STATE OF CALIFORNIA - DEPARTMENT OF TRANSPORTATION — Caltrans

MARK	DATE	DESCRIPTIONS	BY	CH'D	CCO#
		REVISIONS			
3	03/27/13	ADDITIONAL SAS MISCELLANEOUS ELECTRICAL CHANGES	RR RSB	RG	191S2
2	03/01/11	BASE INTEGRATION	RSB	WB	150
1	02/25/08	CABLE TRAY CHANGES	JD	RG SE	42S1

CONTRACT CHANGE ORDER NO._____
SHEET _____ OF _____

SAS SUPERSTRUCTURE AND SKYWAY STRUCTURE
GIRDER INTERFACE WESTBOUND

E-101A

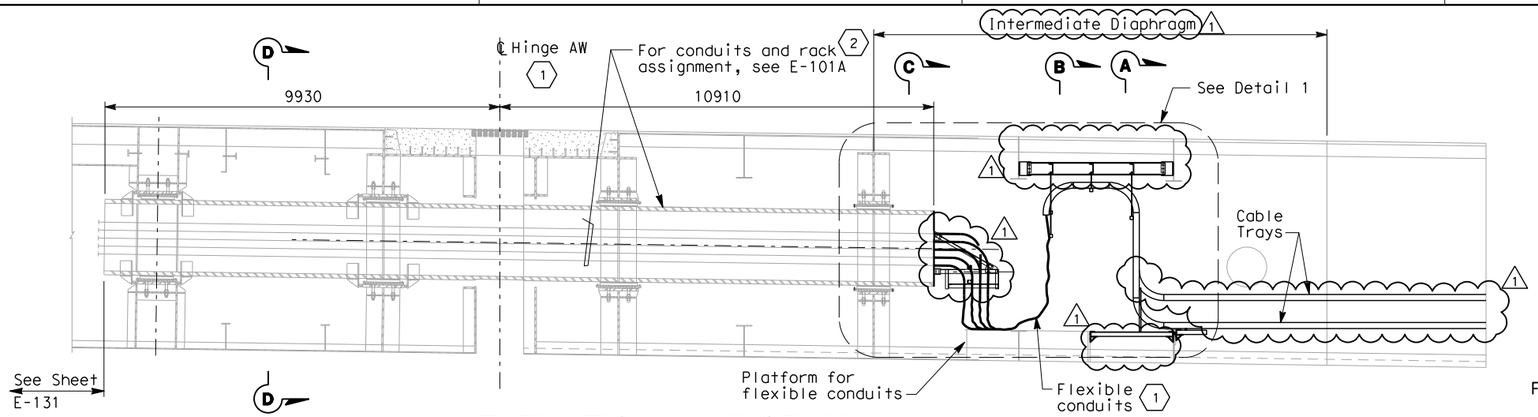
1. Hinge AW electrical design is based on the maximum expansion joint movement opening of 1243 mm.
2. Arrange and group the flexible 103 mm conduits to maintain a minimum voltage level separation of 460 mm between systems.
3. Existing conduits (*) inside pipe beam are supplied in Skyway contract.
4. Terminate conduit to the next lighting fixture and splice wiring to circuit UP131-8 of Skyway Structure. Contractor to adjust as required.
5. Furnish and install 4-25.4 mm innerducts inside TOS/COM conduits (*6520, 6525) and 1-25.4 mm innerduct per BASE fiber optic cable in TOS/COM cable tray.
6. Furnish and install BASE fiber optic cable in innerduct inside TOS/COM conduit and cable tray. See sheet E-1100.

E-132A

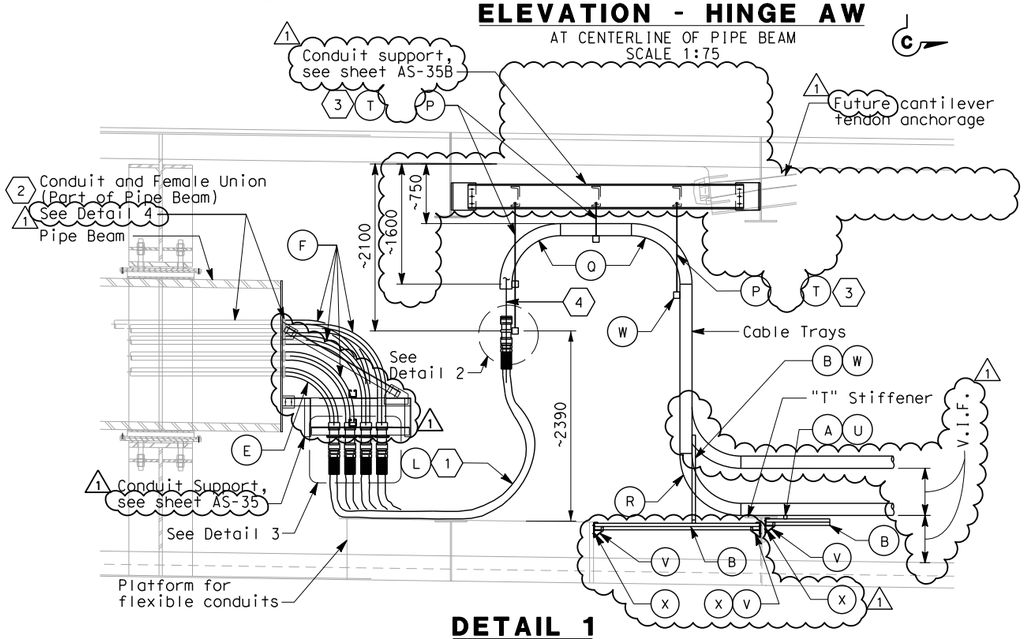
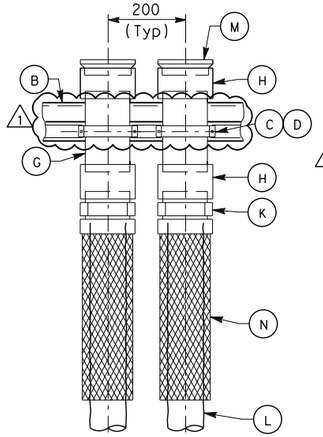
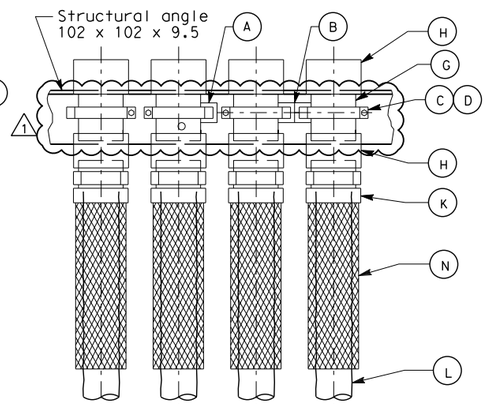
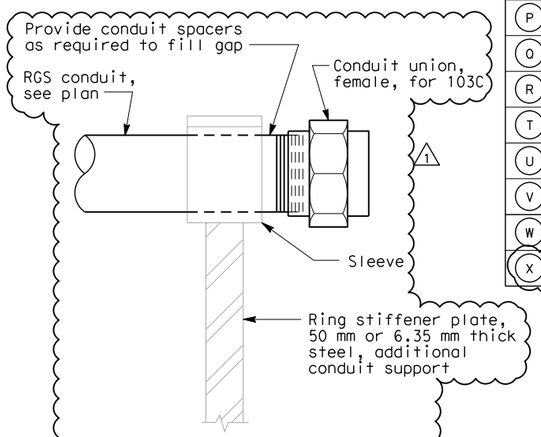
1. Hinge AW electrical design is based on the maximum expansion joint movement opening of 1243 mm.
2. Conduits through pipe beam shall be part of the pipe beam assembly. Conduit shall be welded together to form a continuous conduit inside the pipe beam, length as specified. The weld shall be smooth on the outside and free of burrs inside the conduit. Conduit fittings, like coupling, etc. to form a continuous conduit shall not be permitted as alternative. Pipe beam supplied by Skyway Structure.

The intent of the conduit design is to be able to remove the entire length of conduit inside the pipe beam, in case maintenance is required inside the pipe beam assembly.
3. Cable tray hangers shall be located to provide working space in front of Cantilever tendon anchorage. Field to adjust location accordingly, additional supports as required.
4. All cable/cables entering the liquidtight conduits from the cable trays shall be provided with strain relief cable/cables grips or AMTEC conduit riser grip 1 attached from the vertical cable tray rungs. 1

MARK	DATE	DESCRIPTIONS	BY	CH'D	CCO#
		REVISIONS			
1	03/27/13	ADDITIONAL SAS MISCELLANEOUS ELECTRICAL CHANGES	RR RSB	RG	191S2

E-132B

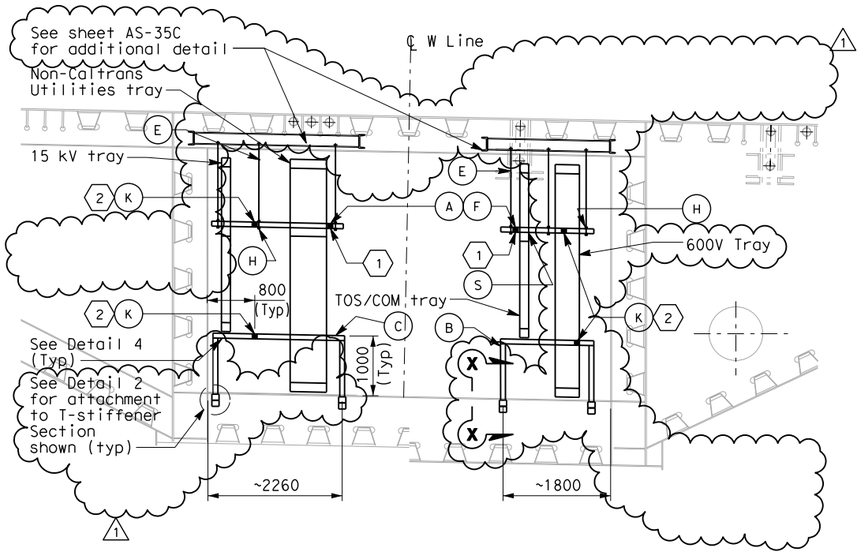
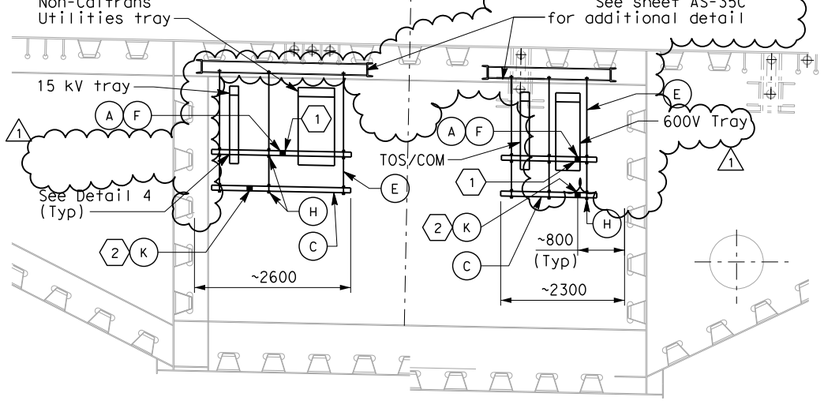
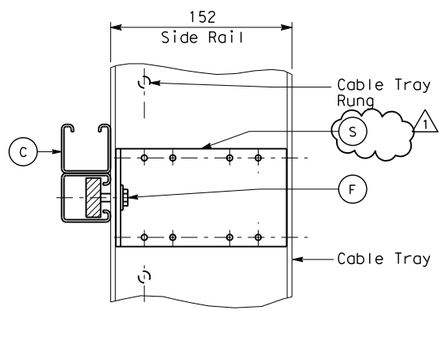
1. For seismic bracing, use strut channel installed diagonally to connect horizontal member of one hanger to horizontal member of adjacent hanger. See Sections A-A and B-B for connecting points.
2. For seismic bracing, use strut channel installed diagonally ~~to connect~~ horizontal member of tray support to adjacent support.

MARK	DATE	DESCRIPTIONS	BY	CH'D	CCO#
1	03/27/13	ADDITIONAL SAS MISCELLANEOUS ELECTRICAL CHANGES	RR RSB	RG	191S2

E-132C

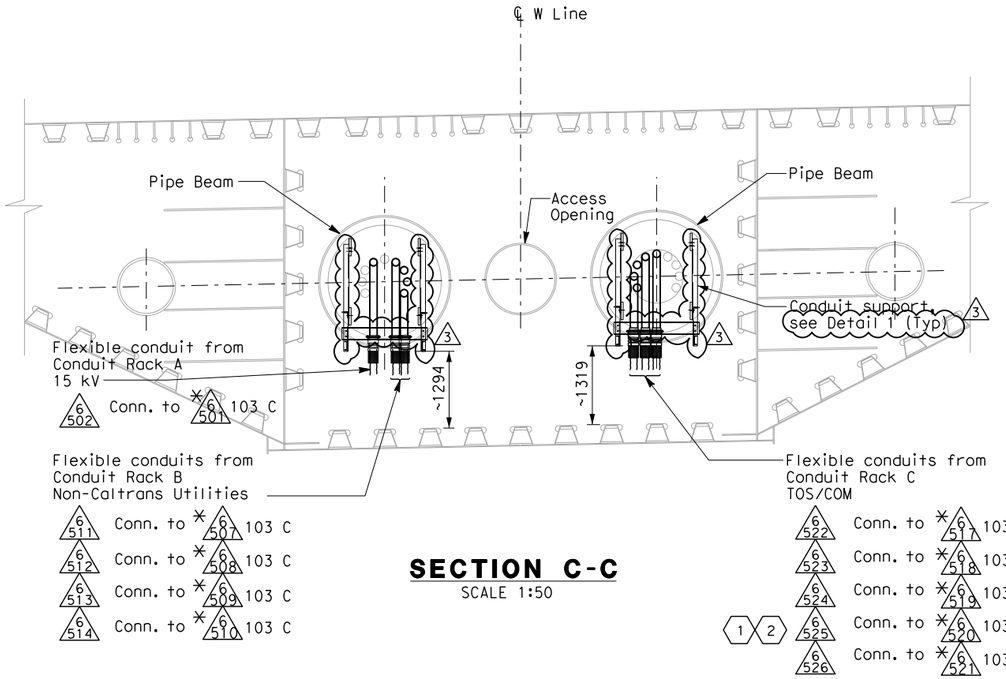
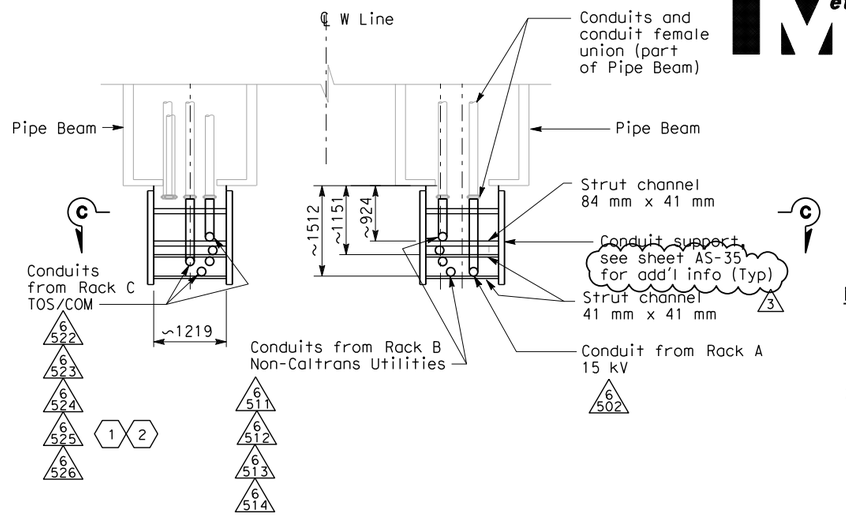
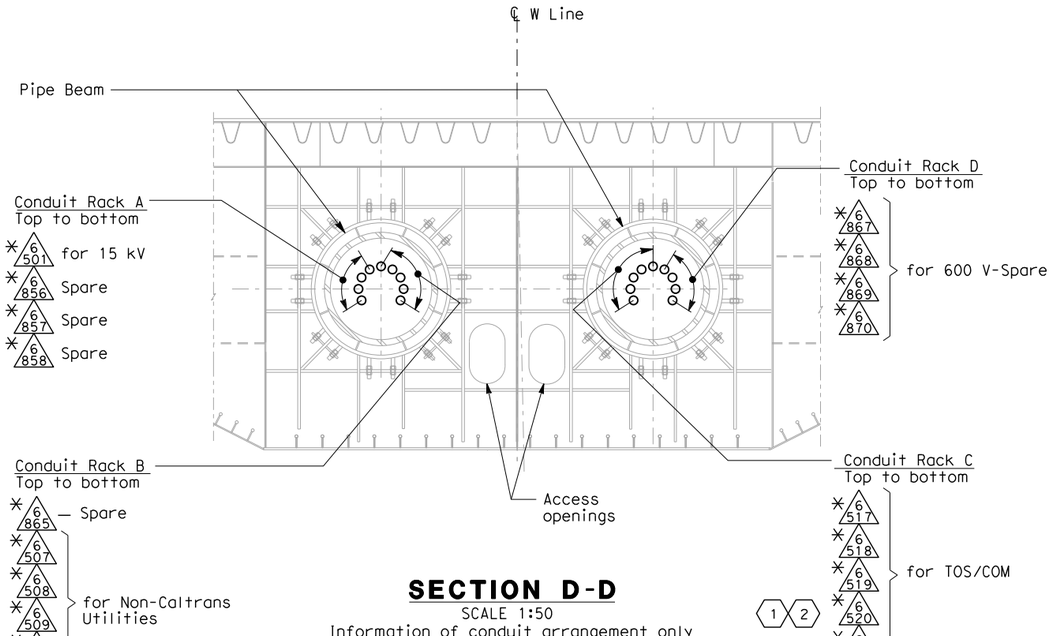
(1) Furnish and install 4-25.4 mm innerducts inside TOS/COM conduits (*6520, 6525) and 1-25.4 mm innerduct per BASE fiber optic cable in TOS/COM cable tray.

(2) Furnish and install BASE fiber optic cable in innerduct inside TOS/COM conduit and cable tray. See sheet E-1100.

MARK	DATE	DESCRIPTIONS	BY	CH'D	CCO#
		REVISIONS			
3	03/27/13	ADDITIONAL SAS MISCELLANEOUS ELECTRICAL CHANGES	RR RSB	RG	191S2
2	03/01/11	BASE INTEGRATION	RSB	WB	150
1	02/25/08	CABLE TRAY CHANGES	JD	RG SE	42S1

E-173

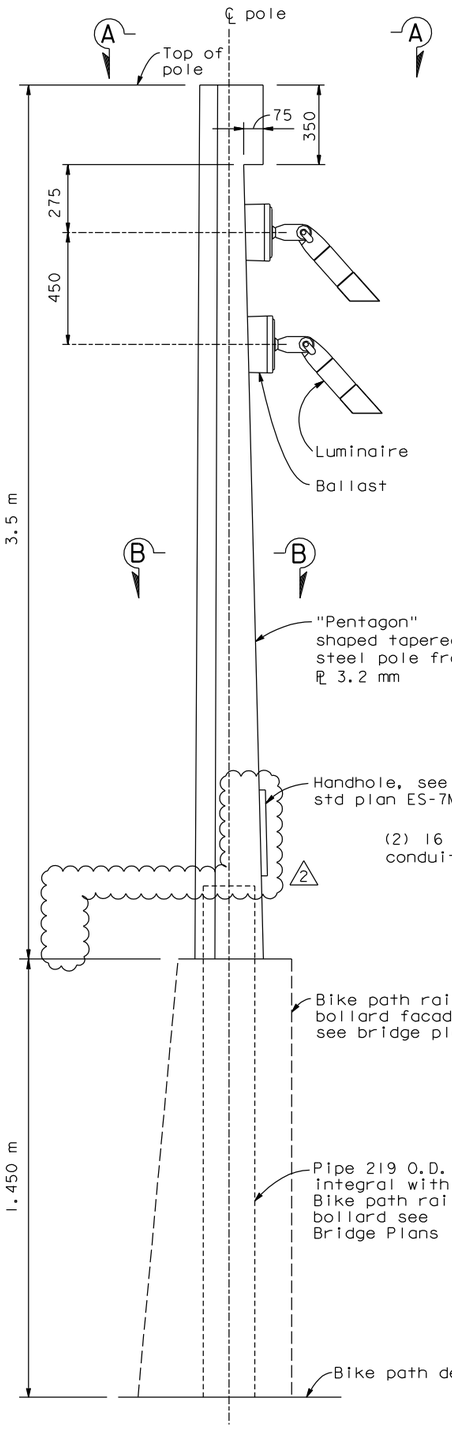
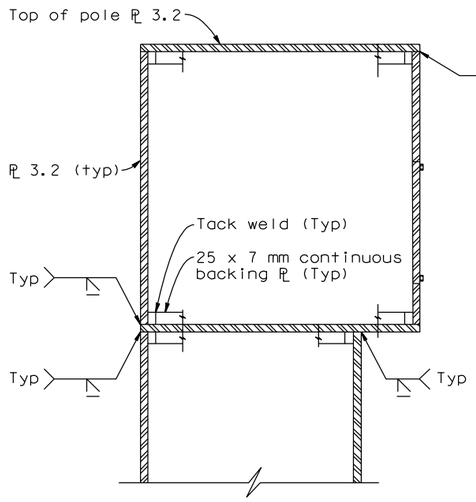
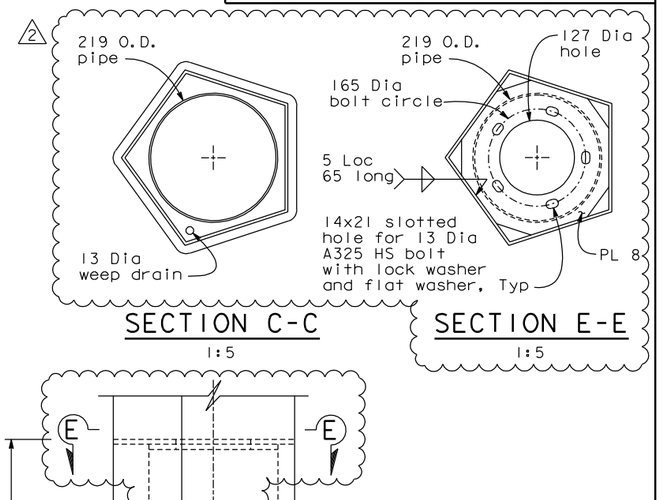
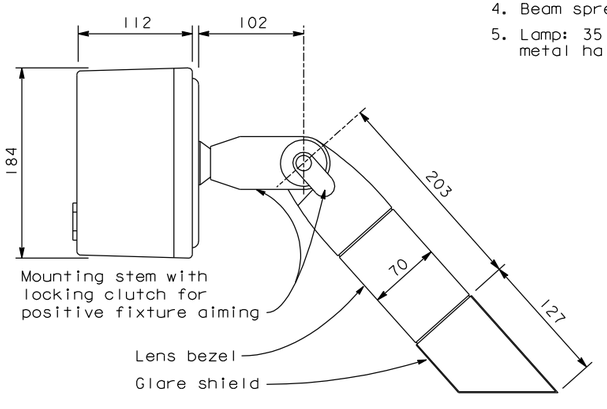
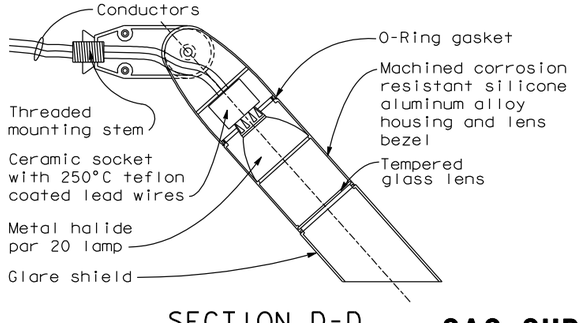
(Verify fit with Bike path railing bollard fabricator)

* * * POLES WILL BE STATE FURNISHED * * *
DETAILS ARE SHOWN IN CONTRACT NO. BATA 007

MARK	DATE	DESCRIPTIONS	BY	CH'D	CCO#
2	03/08/13	ADDITIONAL MISCELLANEOUS ELECTRICAL	JB	TS	191S2
1	04/22/11	STATE FURNISHED LIGHT POLES	JB	TS	43S1
REVISIONS

E-221A

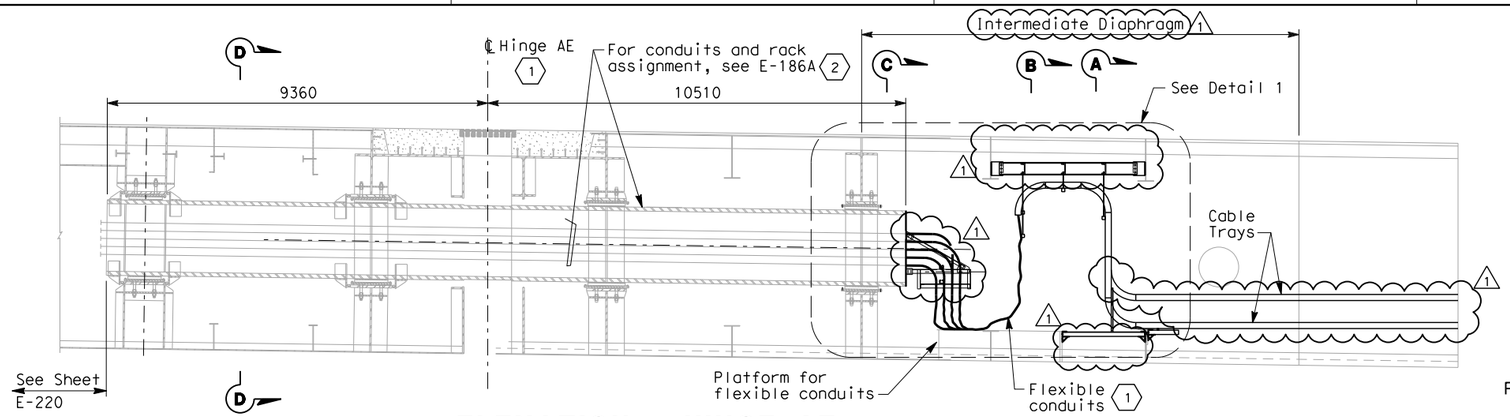
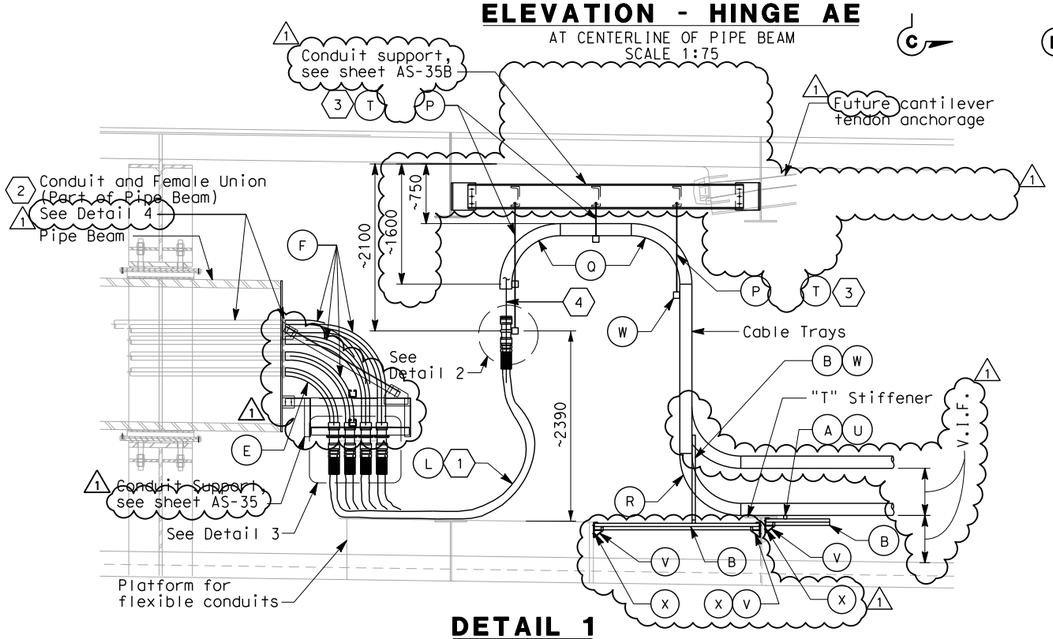
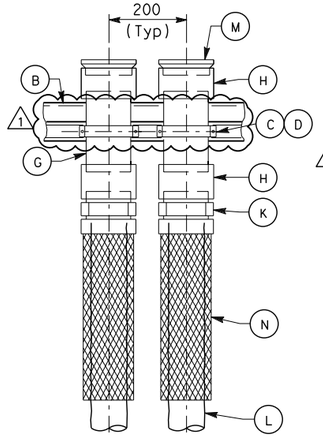
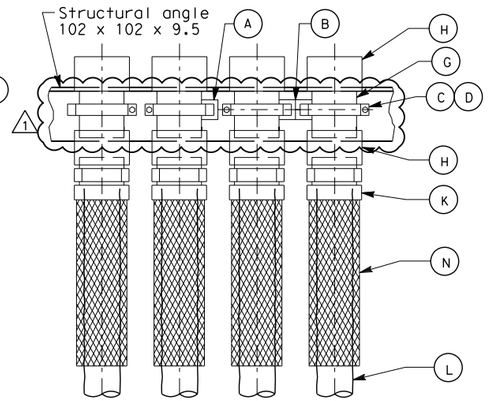
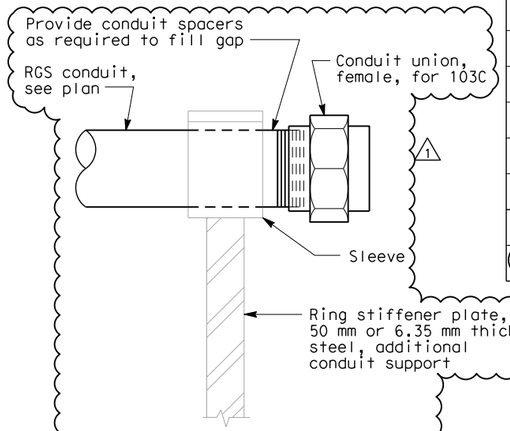
1. Hinge AE electrical design is based on the maximum expansion joint movement opening of 1243 mm.
2. Conduits through pipe beam shall be part of the pipe beam assembly. Conduit shall be welded together to form a continuous conduit inside the pipe beam, length as specified. The weld shall be smooth on the outside and free of burrs inside the conduit. Conduit fittings, like coupling, etc. to form a continuous conduit shall not be permitted as alternative. Pipe beam supplied by Skyway Structure.

The intent of the conduit design is to be able to remove the entire length of conduit inside the pipe beam, in case maintenance is required inside the pipe beam assembly.
3. Cable tray hangers shall be located to provide working space in front of cantilever tendon anchorage. Field to adjust location accordingly, additional supports as required.
4. All cable/cables entering the liquidtight conduits from the cable trays shall be provided with strain relief cable/cables grips (or AMTEC conduit riser grip) attached from the vertical cable tray rungs. 1 1

MARK	DATE	DESCRIPTIONS	BY	CH'D	CCO#
		REVISIONS			
1	03/27/13	ADDITIONAL SAS MISCELLANEOUS ELECTRICAL CHANGES	RR RSB	RG	191S2

E-221B

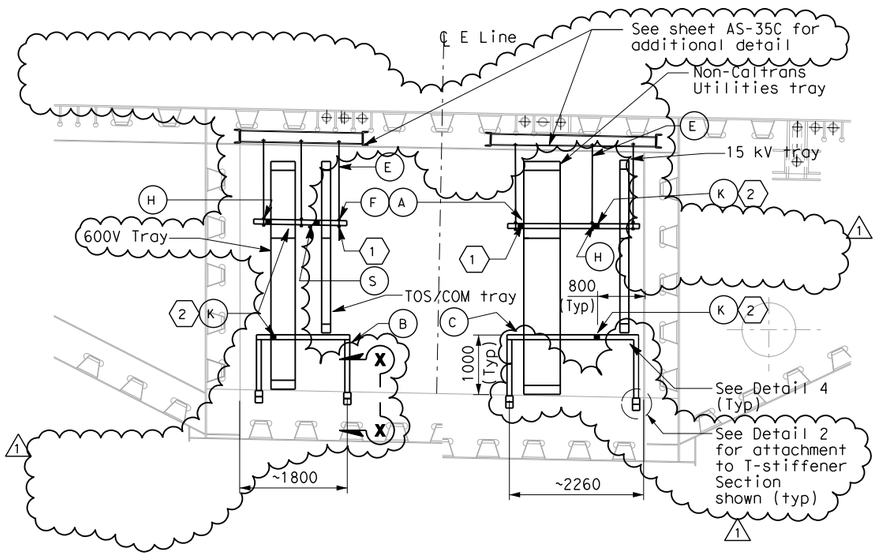
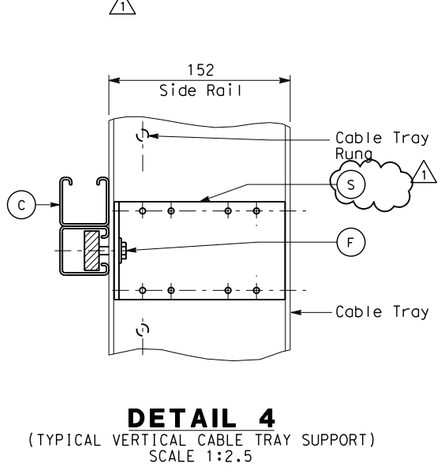
1. For seismic bracing, use strut channel installed diagonally to connect horizontal member of one hanger to horizontal member of adjacent hanger. See Sections A-A and B-B for connecting points.
2. For seismic bracing, use strut channel installed diagonally ~~to connect~~ horizontal member of tray support to adjacent support.

REQUEST FOR INFORMATION NOT ADDRESSED IN THIS CCO REMAIN IN FORCE					
MARK	DATE	DESCRIPTIONS	BY	CH'D	CCO#
1	03/27/13	ADDITIONAL SAS MISCELLANEOUS ELECTRICAL CHANGES	RR RSB	RG	191S2
REVISIONS
